## Addendum No. 03

**Subject:** Martha Washington: Contract Nos. 2022-003G, 2022-003E

**Location:** Martha Washington Elementary: 766 N. 44<sup>th</sup> Street Philadelphia, PA 19104

**This Addendum dated 24 of February 2022, shall modify and become part of the Contract Documents for the work of this project. Any items not mentioned herein, or affected by, shall be performed strictly in accordance with the original documents.**

**1 LIGHTING CONTROL DETAIL  
TYPICAL CLASSROOM**  
SCALE: NONE

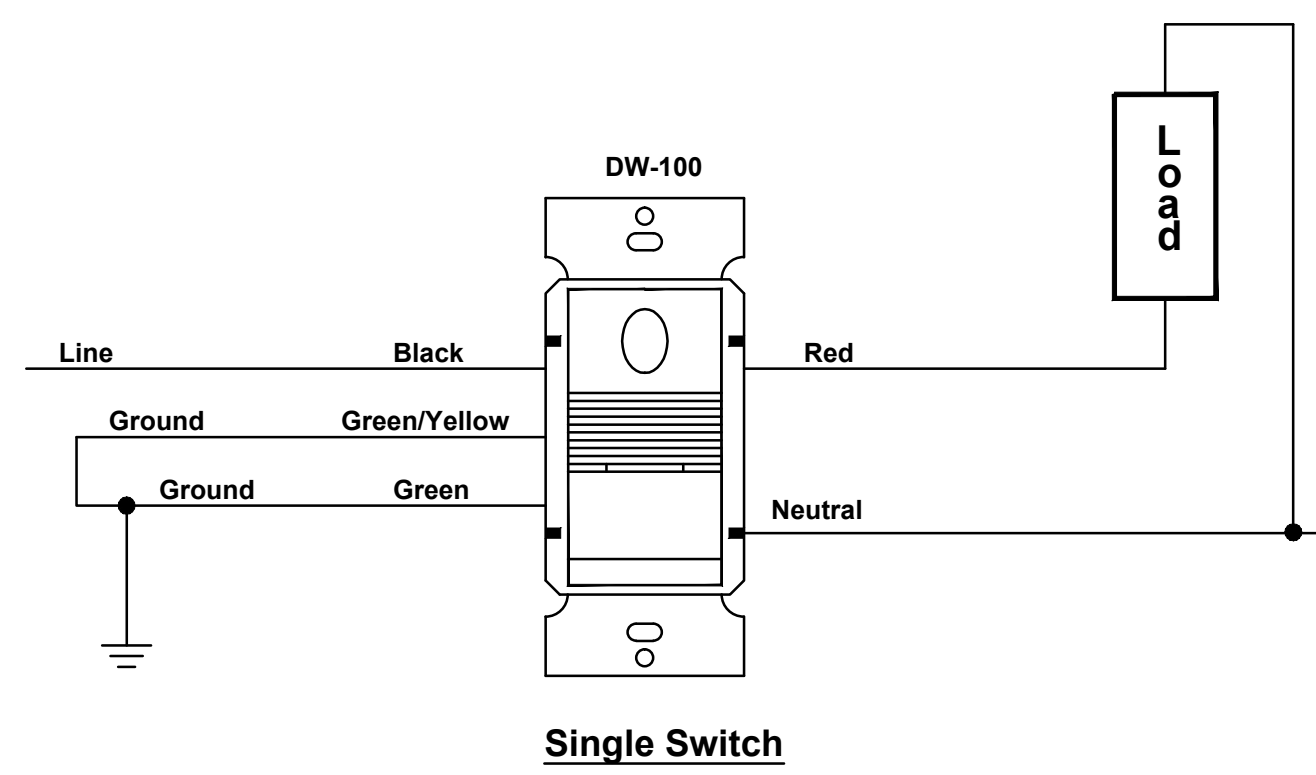
Q12: Drawing E3.01 detail #1 shows a 3-button wall switch Wattstopper #LMSW-103. Please confirm this is the symbol  shown on the floor plans. Please confirm the design intent is to program this LMSW-103 as a dimmer and the 3 buttons should be programmed as toggle on/off (1), dimmer raise (2), and dimmer lower (3).

**A12: Confirmed. Refer to Sequence of Operation for additional info.**

**4 TYPICAL LIGHTING CONTROL DETAIL  
VACANCY SENSORS**  
SCALE: NONE

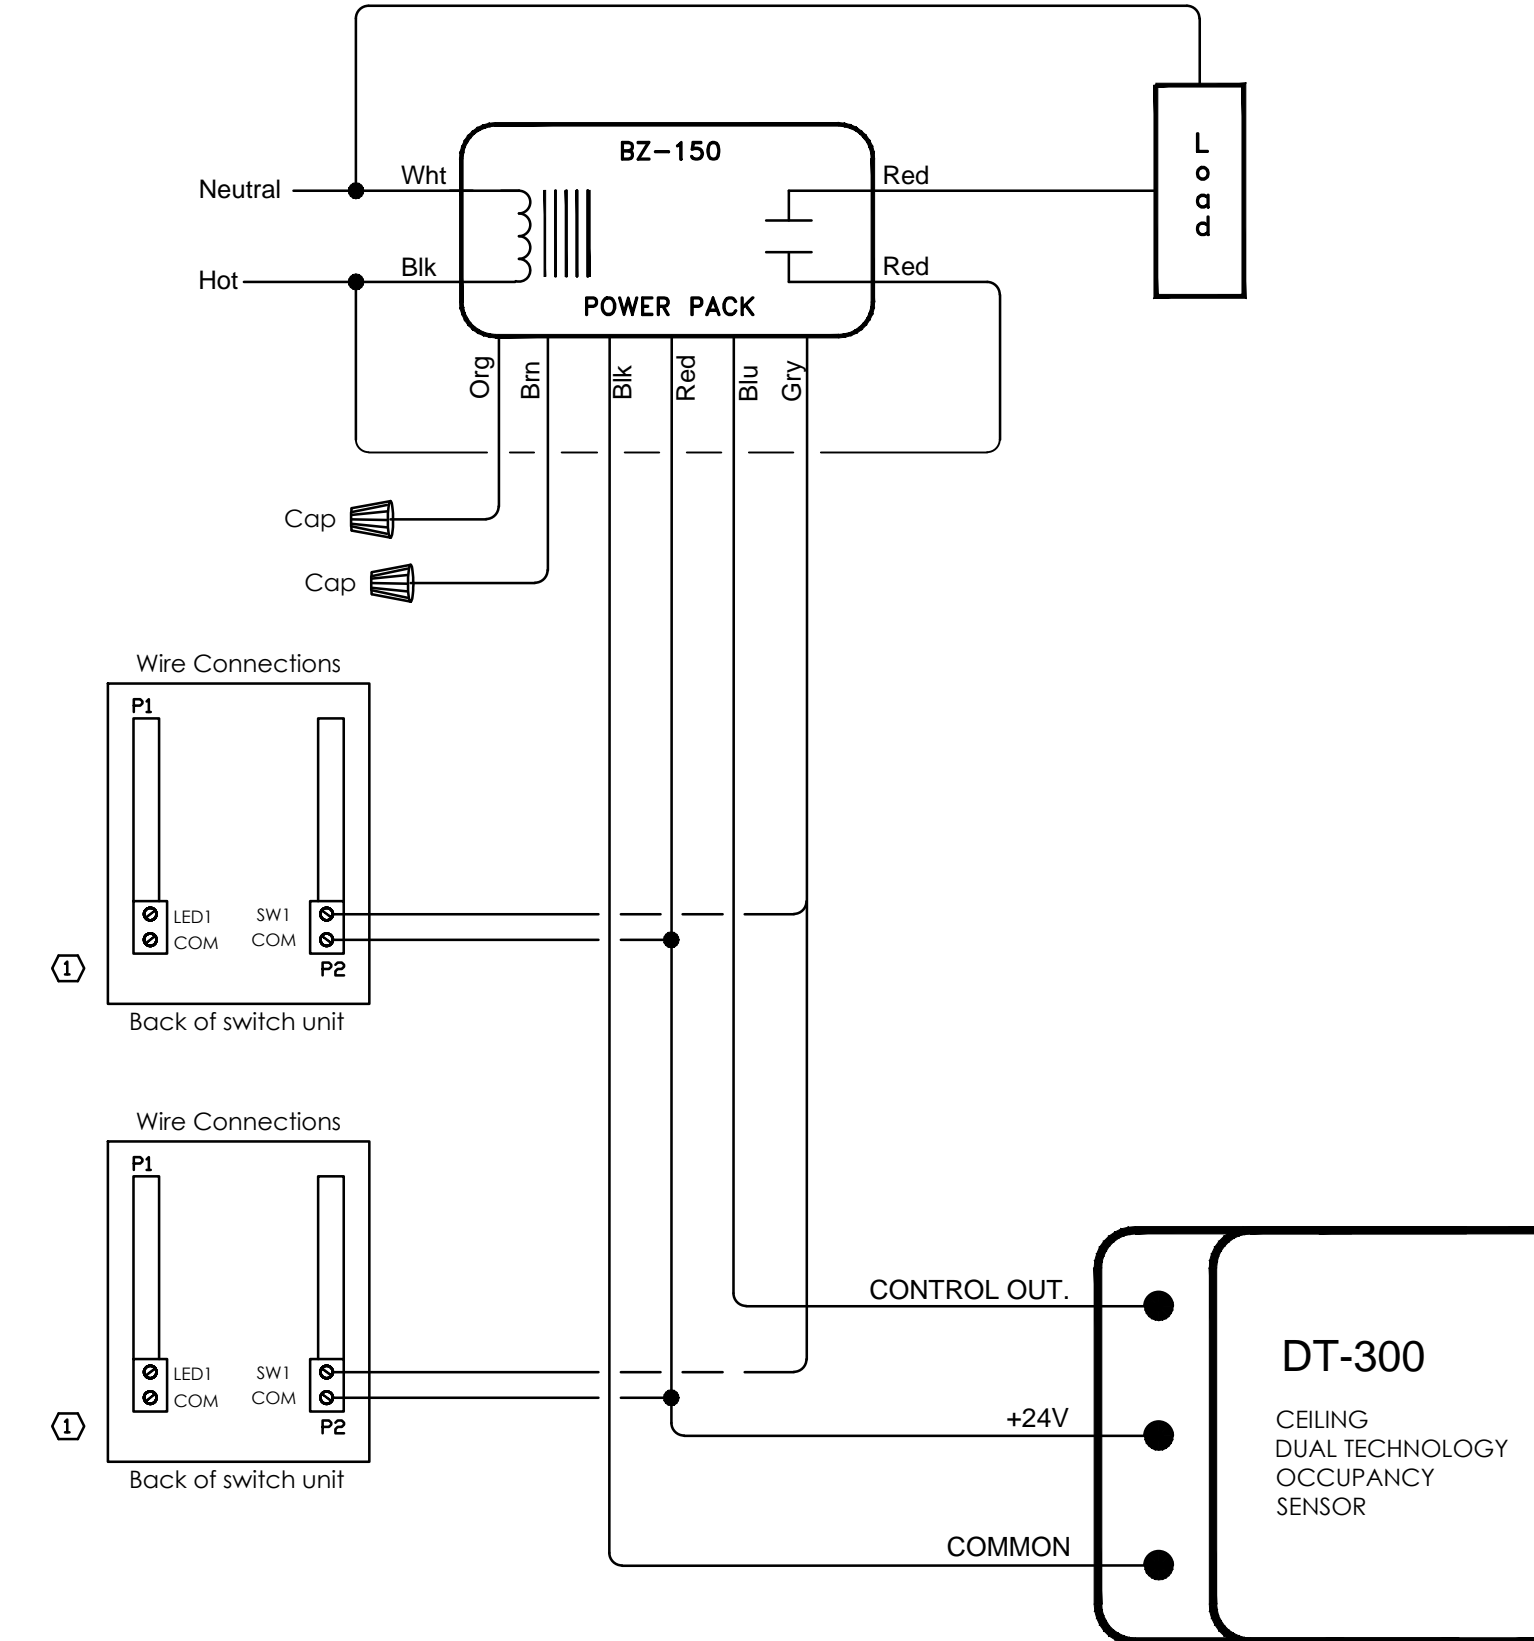
Q13: For the following rooms on drawing E2.01, should these be digital controls with 1 zone switched room controller? Or should the controls be non-digital per drawing E3.01 detail #4 with momentary low voltage

switches, momentary power pack, and non-digital occupancy sensor? Please provide basis of design Wattstopper part numbers for the low voltage switch, occupancy sensor, and power pack/room controller depending on the answer.

- a. Coats 208C
- b. Coats 207C
- c. Coats 109C

**A13: 4/E3.01 is the applicable detail - Refer to attached E3.01 for updated detail.**

**5 SINGLE OCCUPANCY SENSOR CONTROL DETAIL**  
NOT TO SCALE

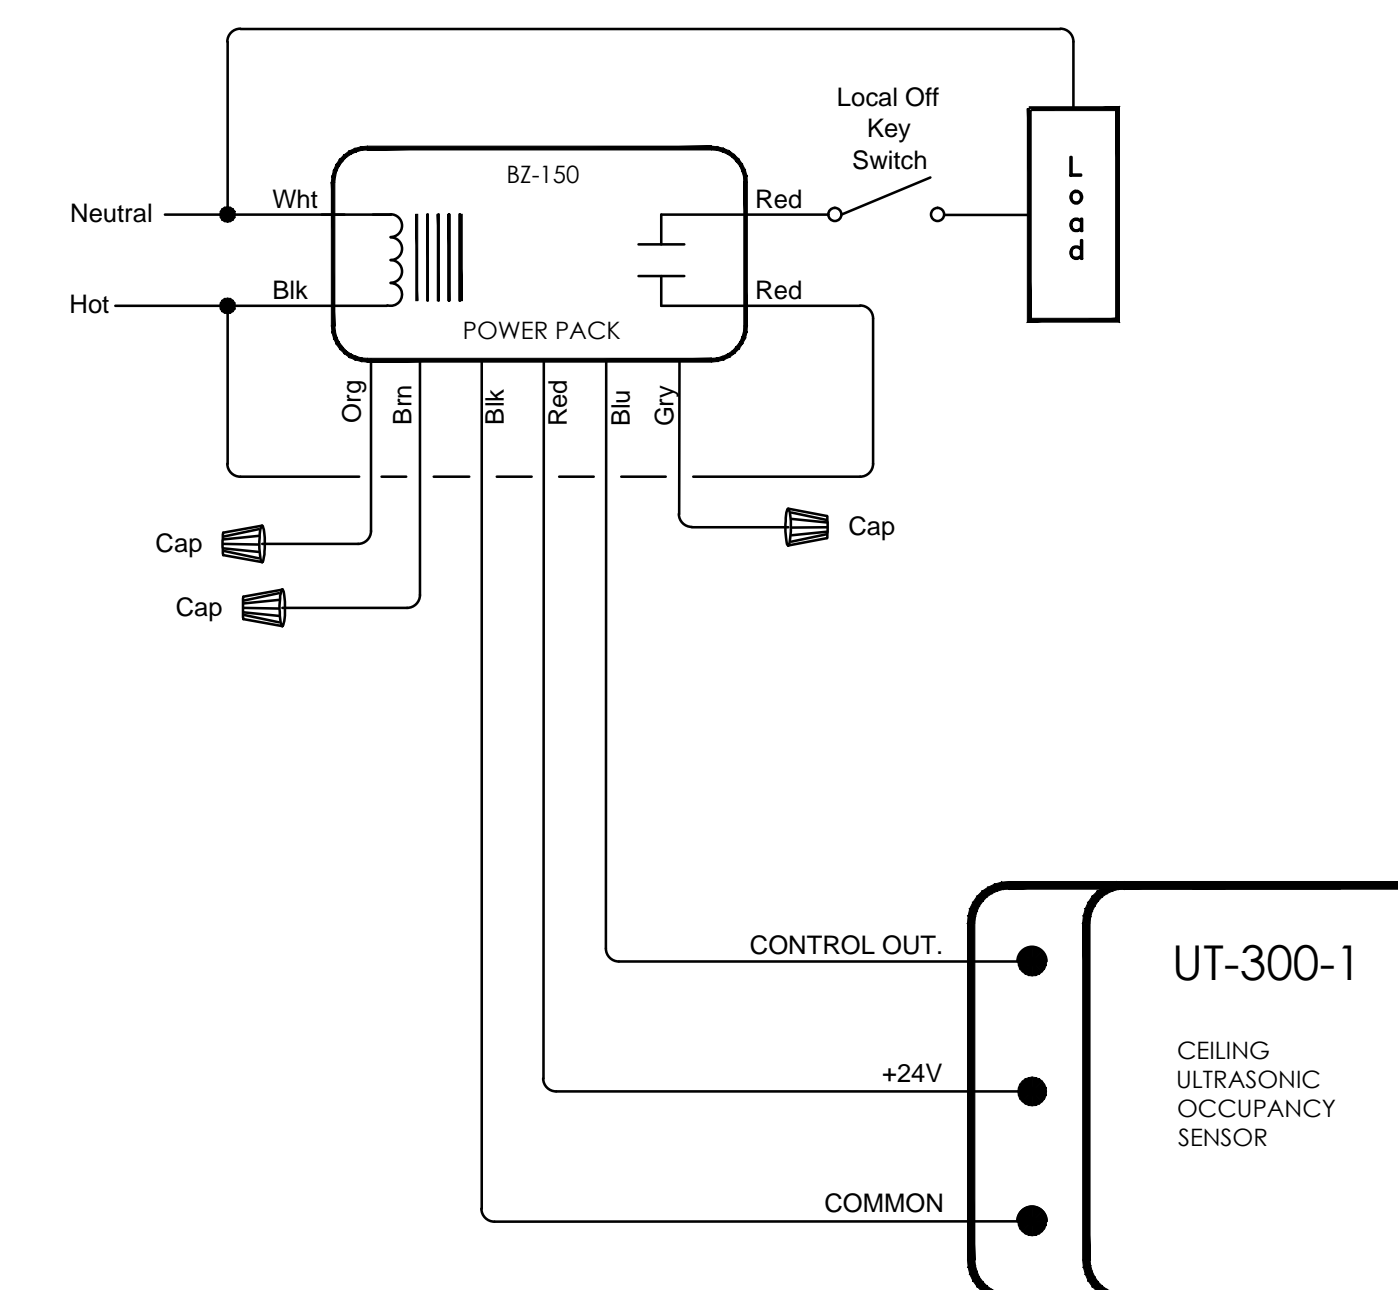
S

**A14: Lighting controls shall be provided as per drawing: one wall occupancy sensor (2/E3.01) for the sink area and ceiling occupancy sensor with override key switch for the toilet area (5/E3.01) - Refer to attached updated E3.01 drawing with added applicable detail 5/E3.01**
